Company	Trenz Electronic GmbH
PCN Number	PCN-20251028
Title	TE0803 Gap Filler Upgrade
Subject	BOM Change
Issue Date	2025-10-31

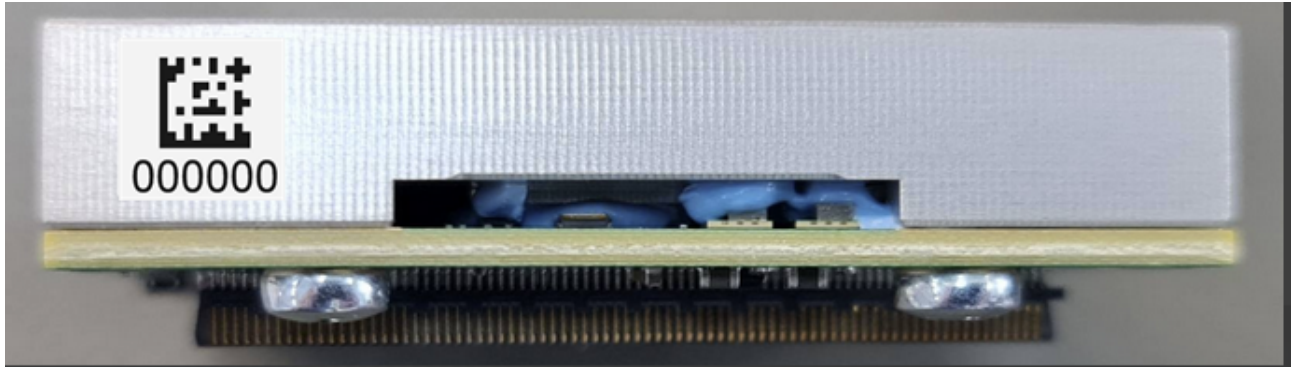
#1 Changed gap filler from GF3500S35-00-60-50CC to GF4500CVO-00-240-50CC.

Type: BOM Change

Reason: Improve thermal conductivity.

Impact: Improved thermal conductivity. Changed colour from blue to pink. For more detailed changes consult gap filler datasheets.
